File: cphp82001-pcb.kicad_sch

Title: CALCPACK HP 82001

Size: A4	Date: 2024-01-23	**Rev: 3.3**
KiCad E.D.A. kicad 7.0.10		Id: 1/1

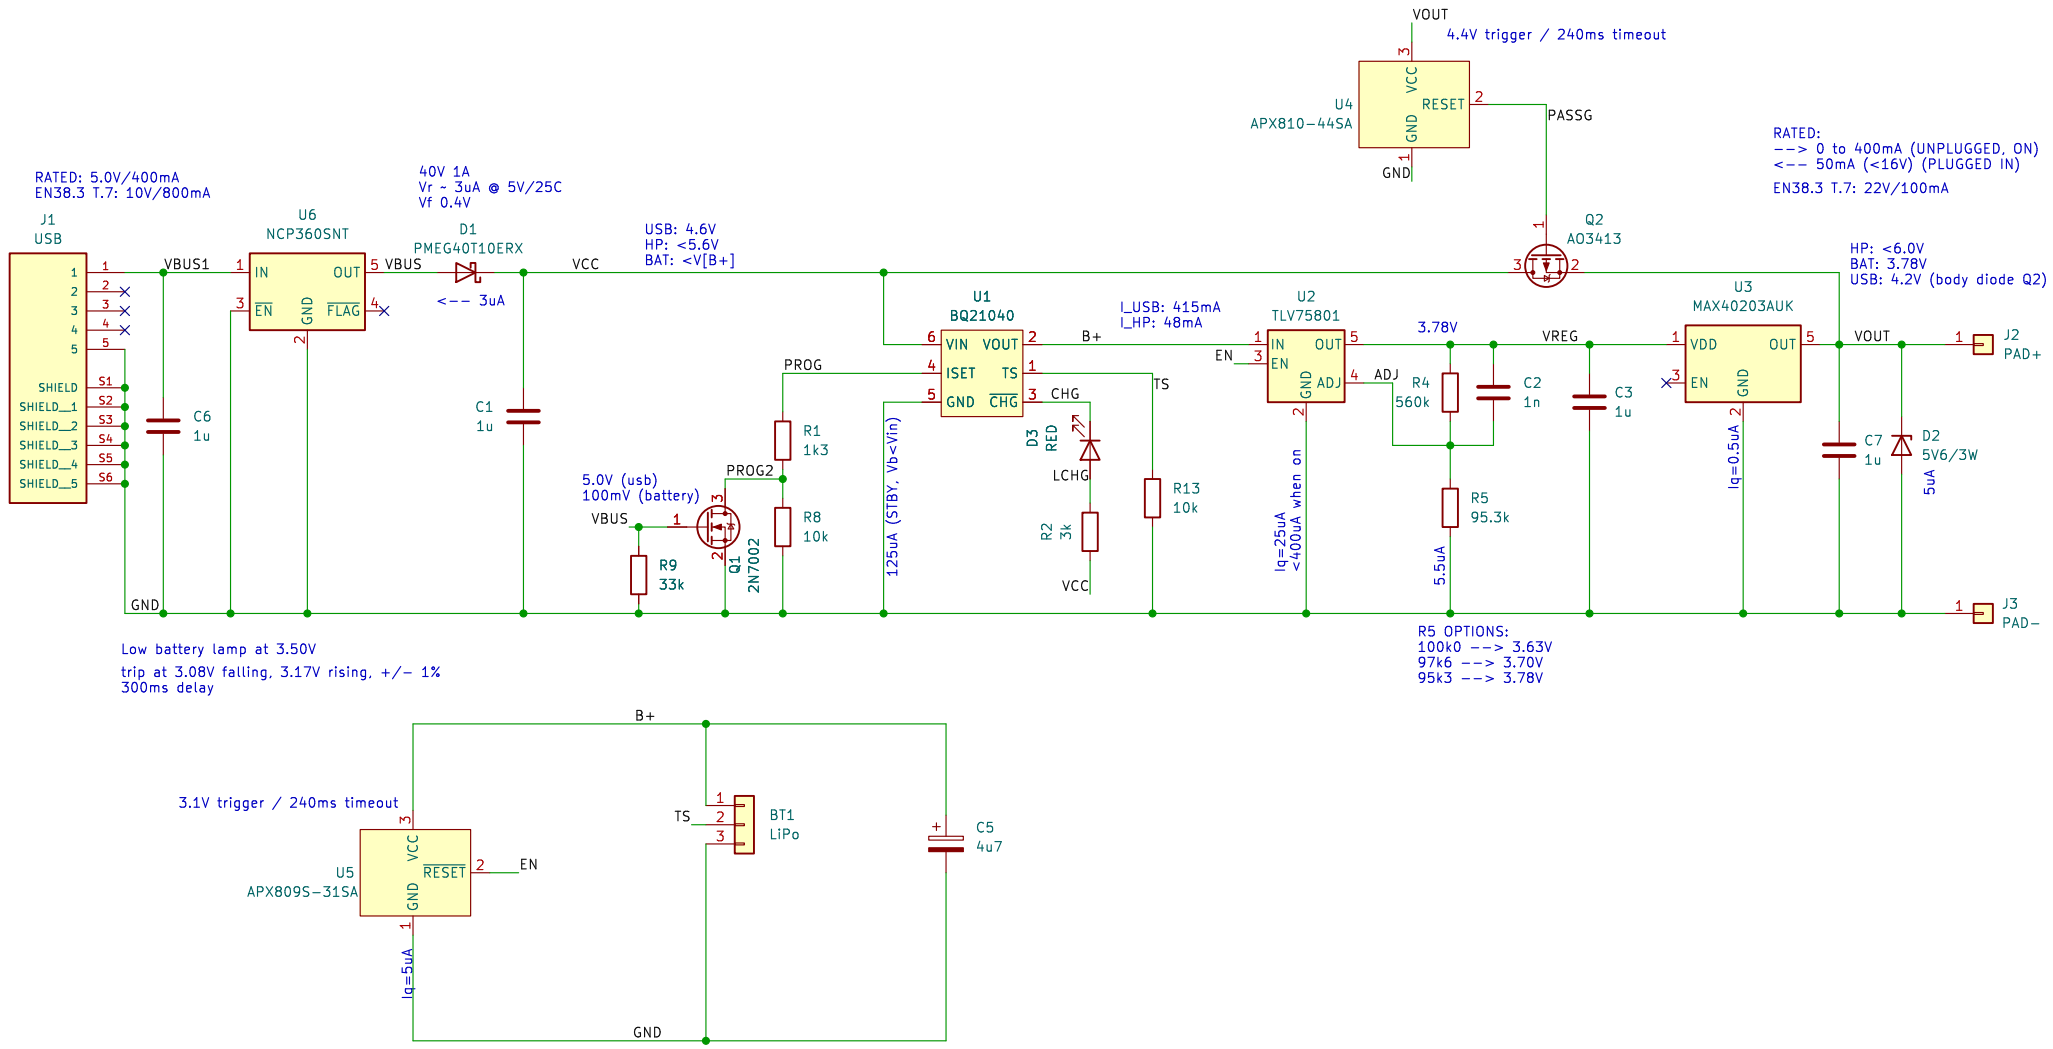
REV1 ADD Q1,R8,R9

REV1.1 U2=TPS73101, U4=S-8261ABJMD, R4=300k, R5=160k, update notes

REV1.2 change D1 to 1N5817, change D2 to 5V6, R8=24k, Add C6

REV2 BOARD LAYOUT CHANGE

REV3 ADD U6, C6, F1. change U4 to TPS3808 (+C4,R6,R7,R10,R11), change U1 to BQ21040, add Q2,D7,R13, move C2, add C7, new name

REV 3.1 remove F1, change R5 to 95.3k

REV 3.2 change U5 to APX

REV 3.3 Add U4,Q2 for active backfeed
